#### COMMISSION OF ARCHITECTURAL REVIEW APPLICATION FOR CERTIFICATE OF APPROPRIATENESS

## 2117 & 2119 Carrington St CAR Revised Review 11/04/19

### Project Name: 2117-2119 Carrington St

#### **Revised Application Narrative**

# FRONT ELEVATION

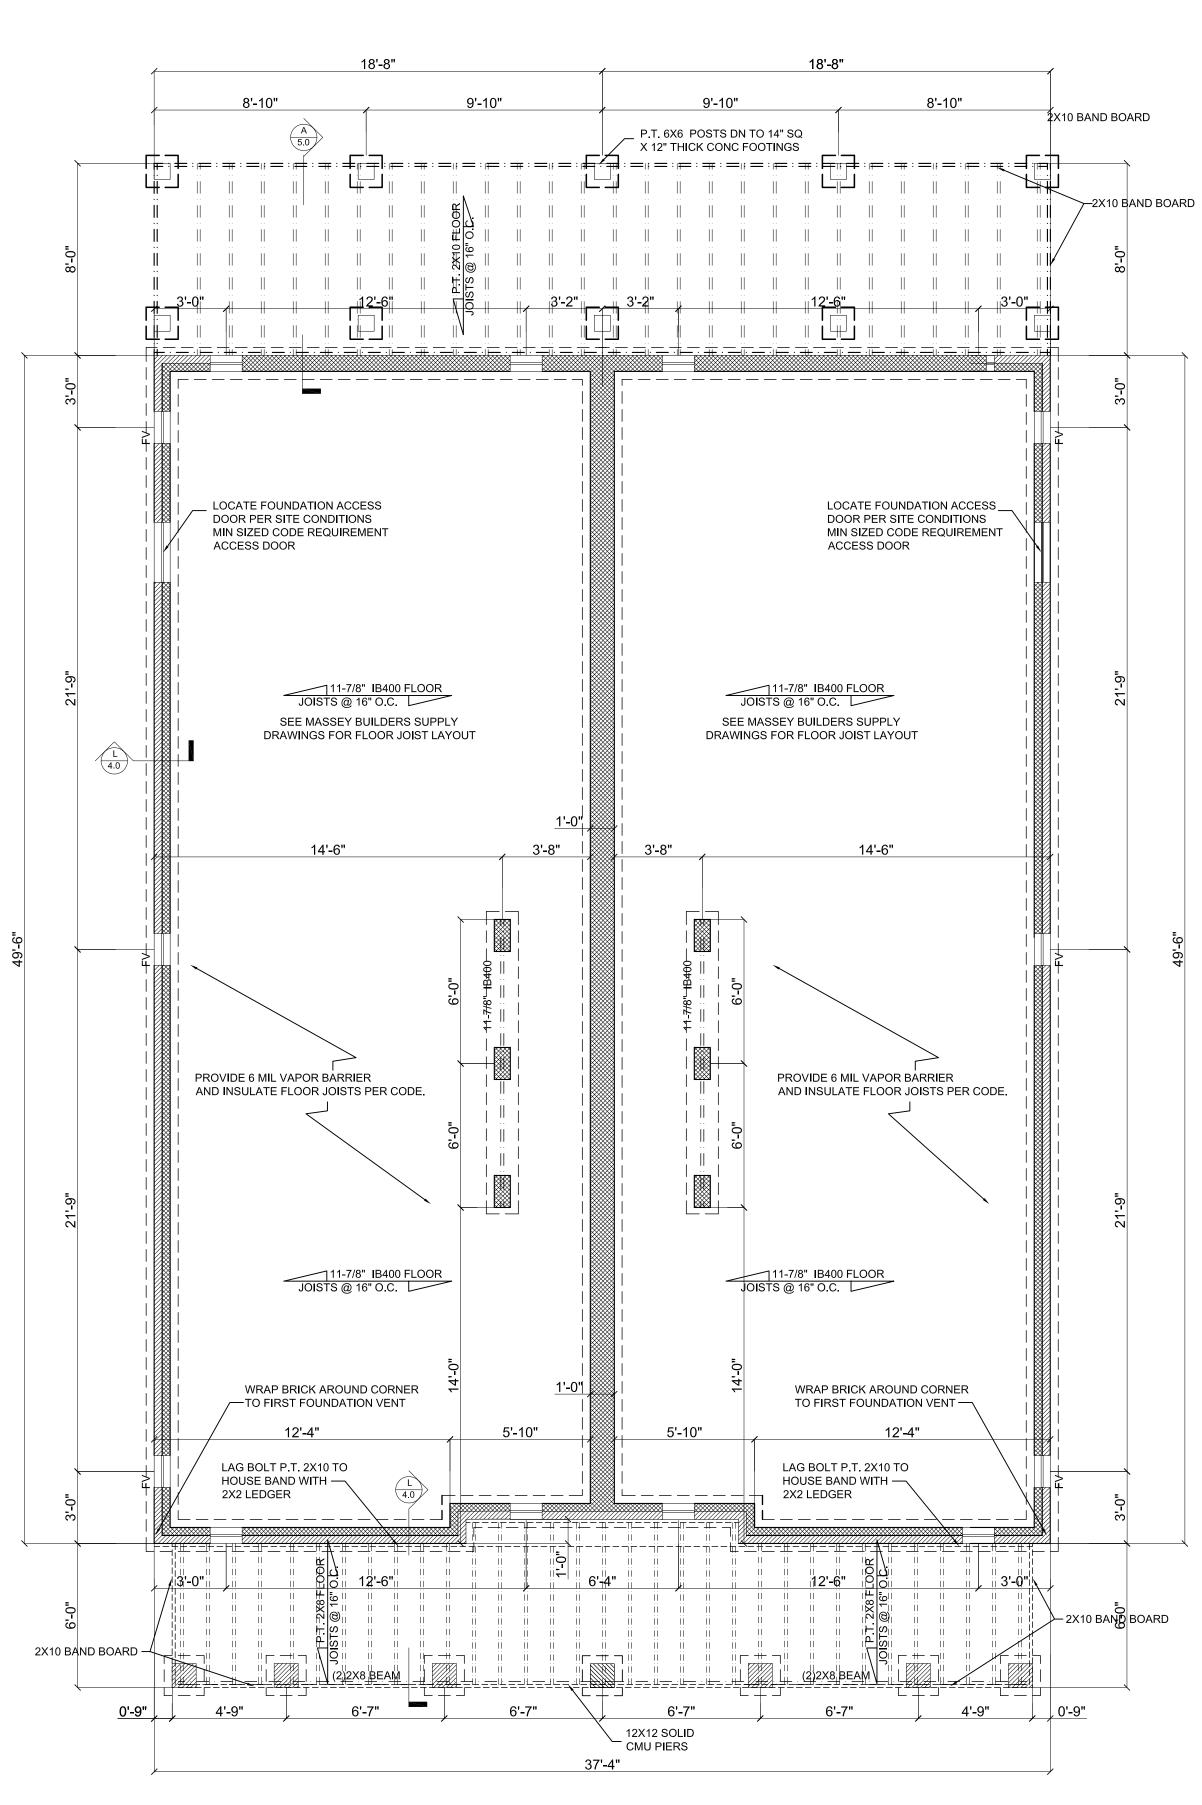
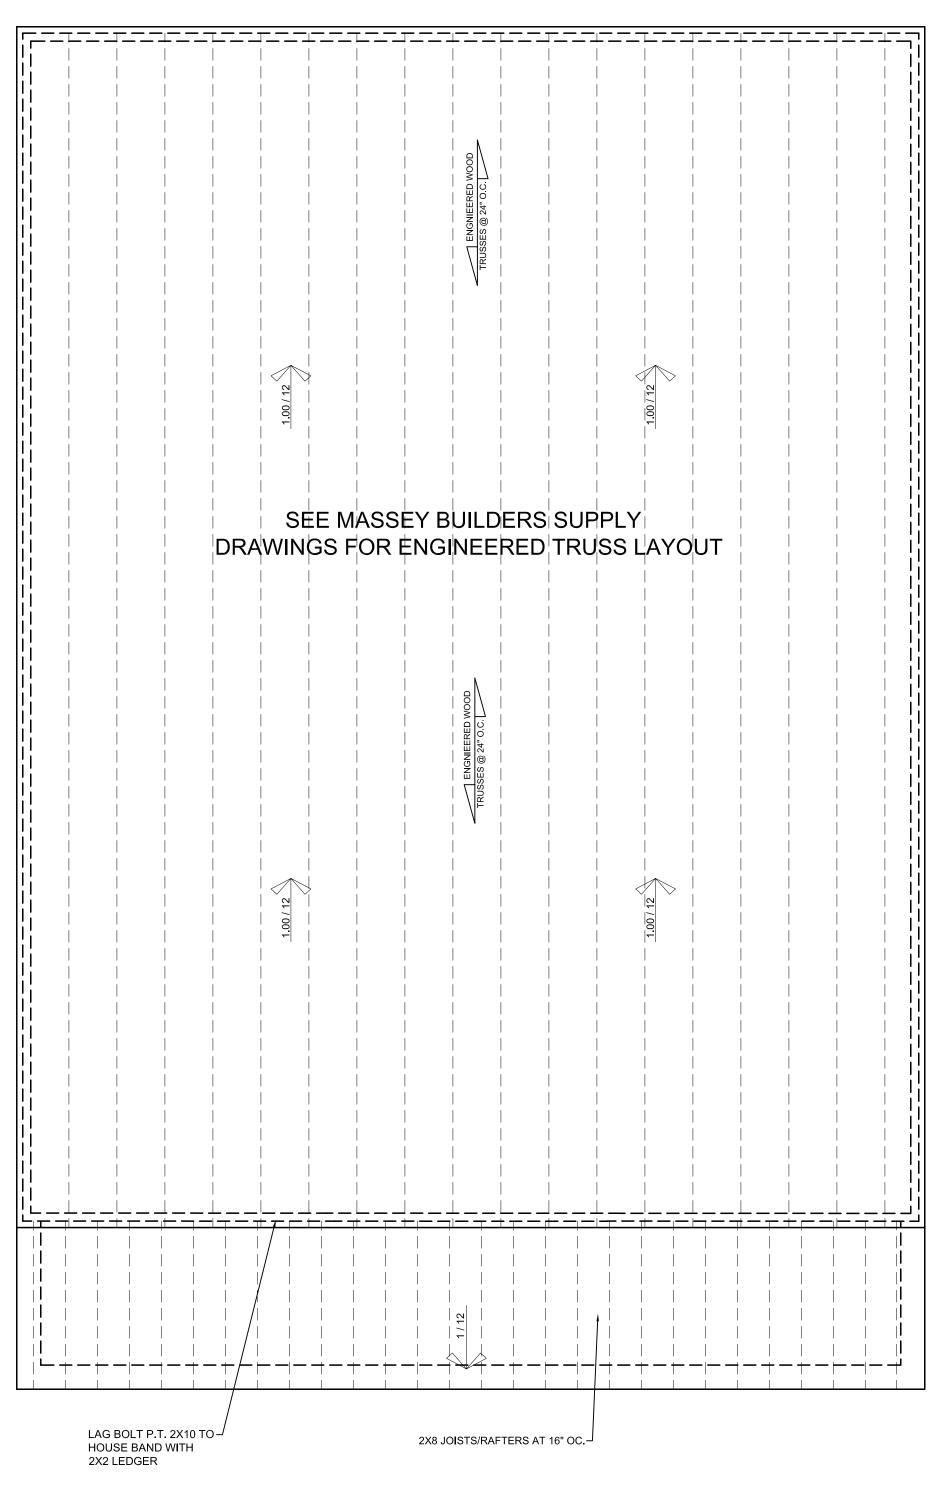
Porch Roof- Needs to be in keeping with the modern design while still providing mass to the front elevation as it does currently. Make porch line squared edges. Removed crown and made the porch roof profile square.

Siding- At the top of the windows to the cornice the gap needs to be less. The amount of siding between the cornice and the top of the windows is too large an needs to be reduced. Needs to be a simple horizontal design element (The siding) Reduced the height of the parapet and removed siding. Makes the gap between the windows and cornice much smaller. It's now a much simpler design element.

Side Elevation- Needs to have vertically aligned windows. Add additional windows to the 2nd story of the visible bays and that the window heads be aligned on the side elevations. Added one more window to the side elevations and aligned it with the window below.
